ADDENDUM NO. 02

IMMOKALEE WATER AND SEWER DISTRICT

Upgrade Lift Stations I, T & V and New Lift Station I2 & Force Main and New Sanitary Sewer and Manholes

September 19, 2013

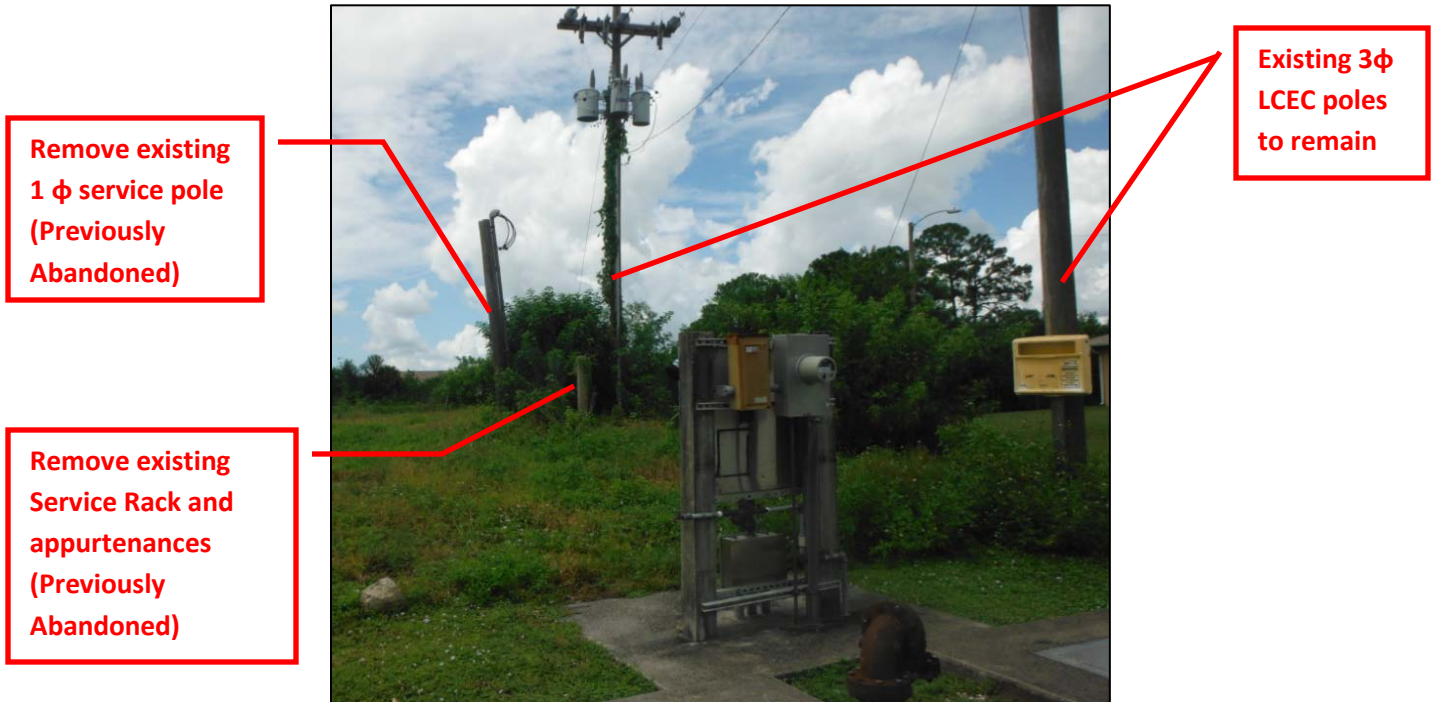
Q11. Referring to LS I , Demo Notes 2 A on sheet E – 2, is the pole to be removed the old Plant service pole located close to LCEC transformer pole? There looks like there is an underground service rack that has been abandoned. Should that equipment be removed also?

A11. Yes – See photo below for further clarification.

C9. Lift Station I - Sink Hole

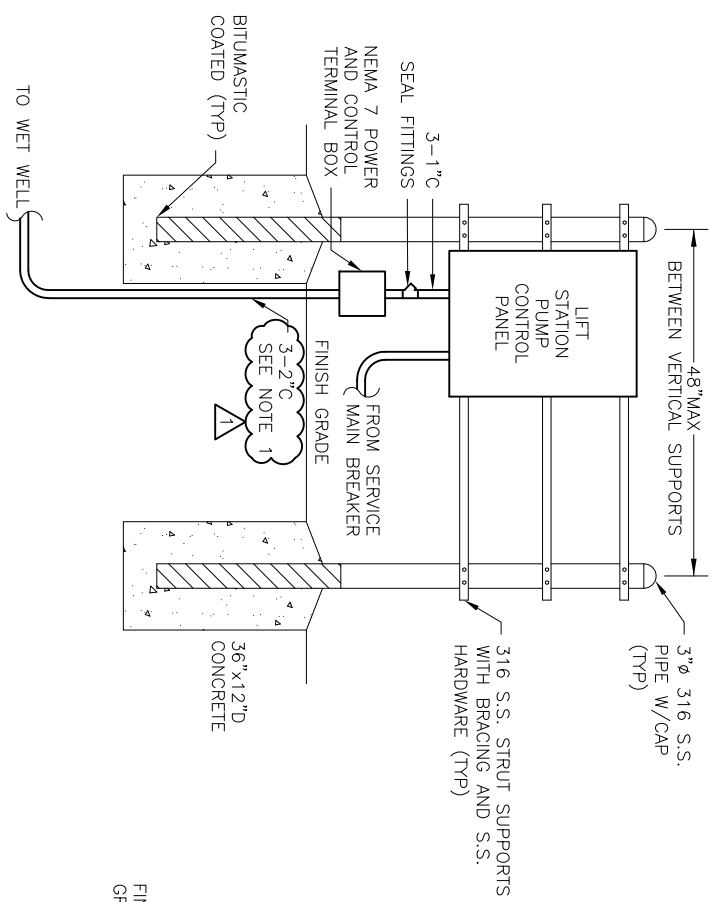
A sink hole has recently developed at Lift Station I, which is apparently due to the existing 8" PVC sewer line running from the master manhole to the wetwell. (See photo below). Pressure grouting of the pipe connection at the wetwell is to be included in the Bid as part of the preparations for coating the existing wetwell (Refer to Paragraph 3.02.E of Specification Section 09910).

SHEET **E4** OF 41
DATE JULY 2013 REV 0

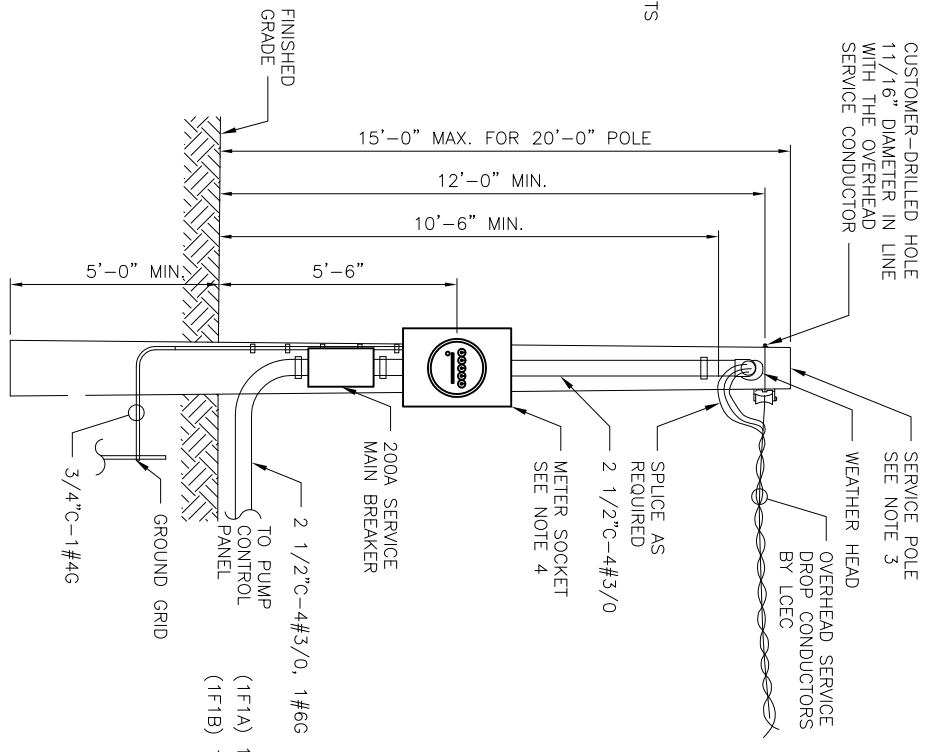
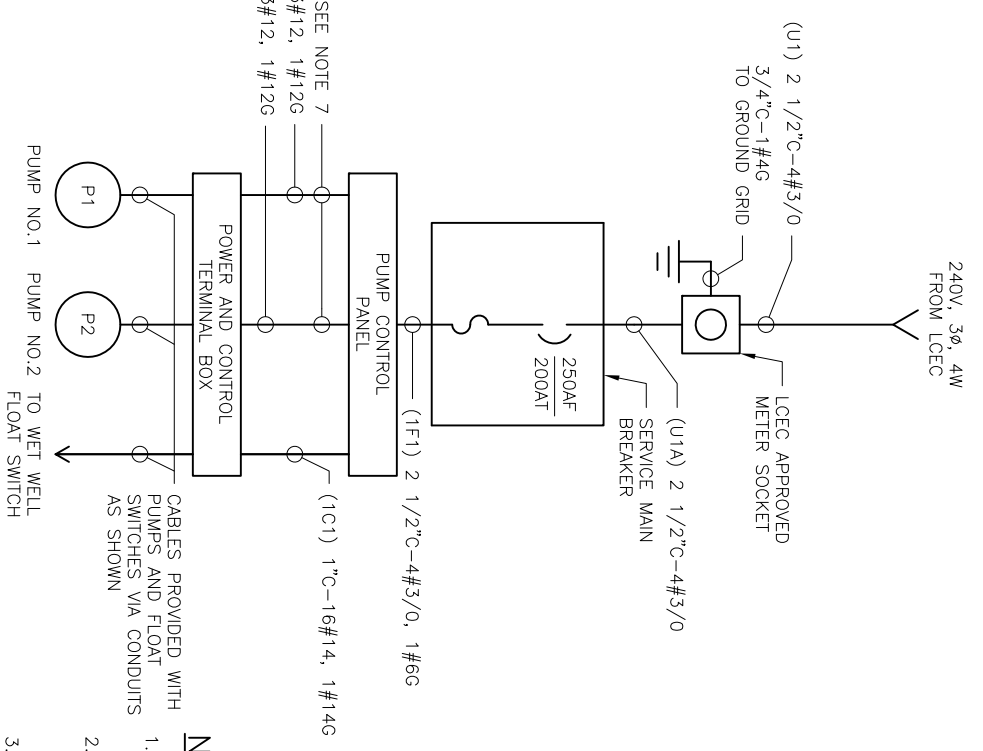
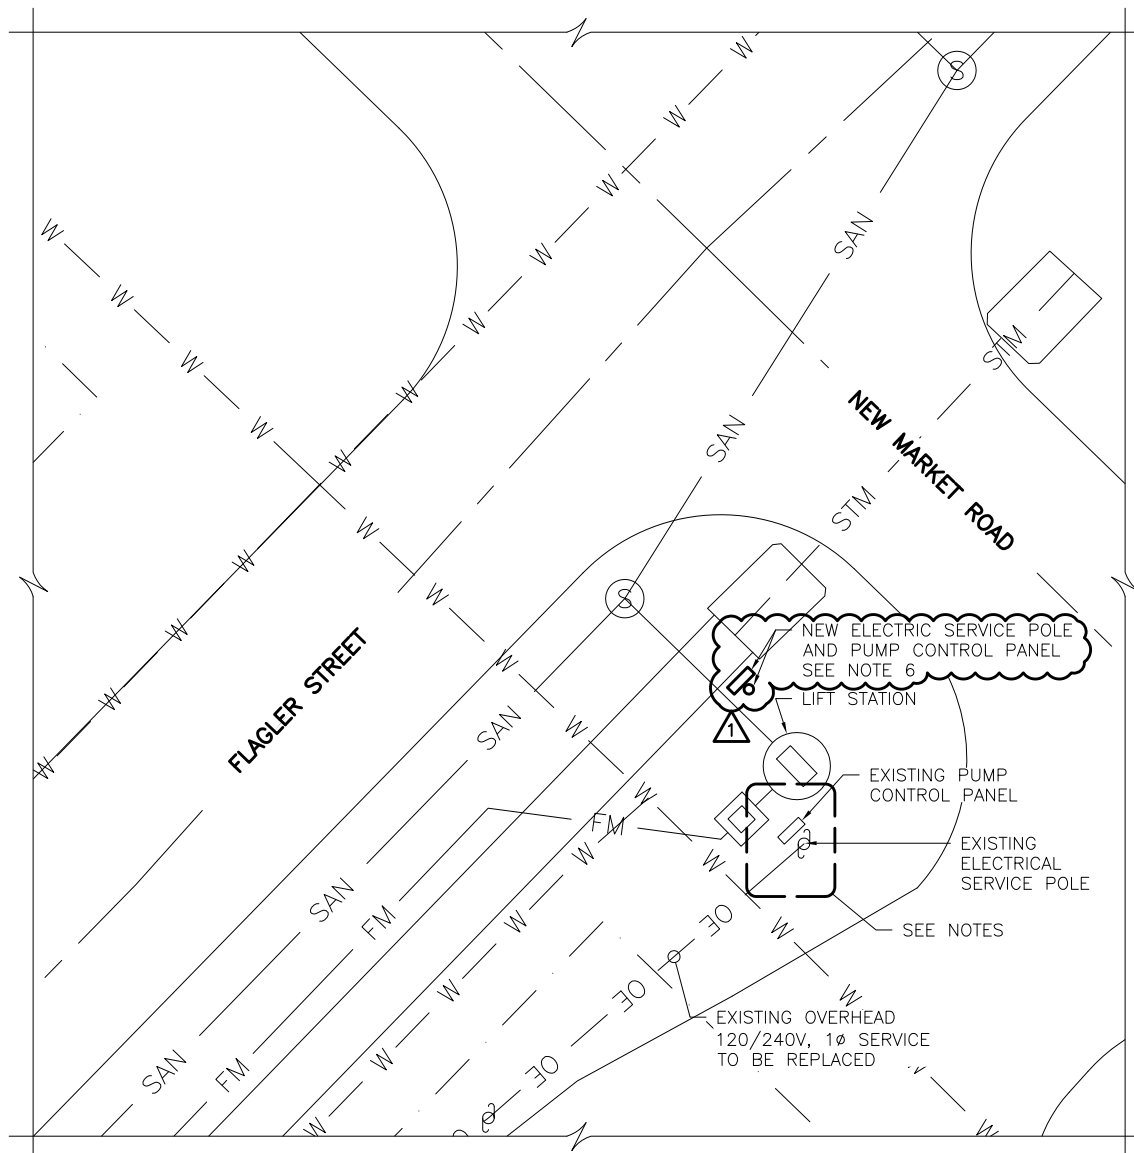
Q8. 1" conduits are to small to handle the pump leads to the wet well, (Hydromatic pumps usually has separate leads for thermals / seal) please confirm. Should we increase wet well conduit to 2" (usual min standard)?

Q12. E - 4 details 200 amp. service and main breaker. Large services for such small stations on 3 phase 240 volt. Largest 7.5 HP approx 20 FLA each, max 80 to 100 main. Did someone do calculations on single phase with drives? Do you really want 200 amp services?

A8. *We have revised Contract Drawing E4 to reflect the upsizing to 2" conduit from the power and control terminal box to the wet well.*

A12. The three phase service was a request by the District and 200 amperes is the minimum size for three phase service per the LCEC service guide.

ELECTRICAL SITE PLANS
LIFT STATIONS 'T' & 'V'

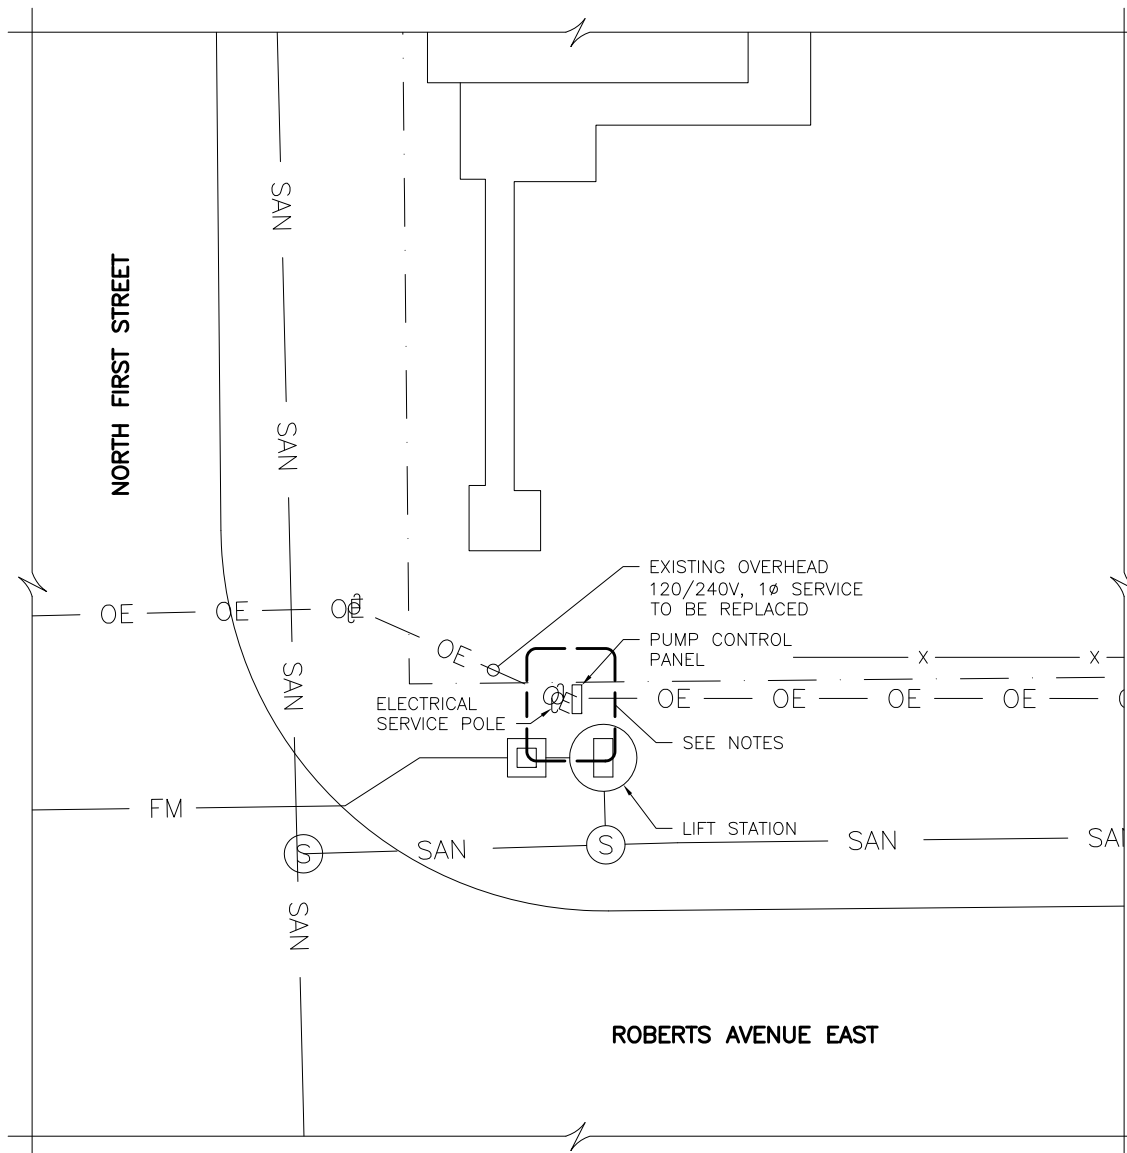
Q10. LS T service pole location. As per walk through with Hector, location of service pole is in the way of the service truck crane. Can or should service pole and panel be relocated to opposite side of the wet well if room to meet boundary spec.?

A10. *We have revised Contract Dwg. E6 to reflect the revised location for the service pole so as not to interfere with the service truck crane.*
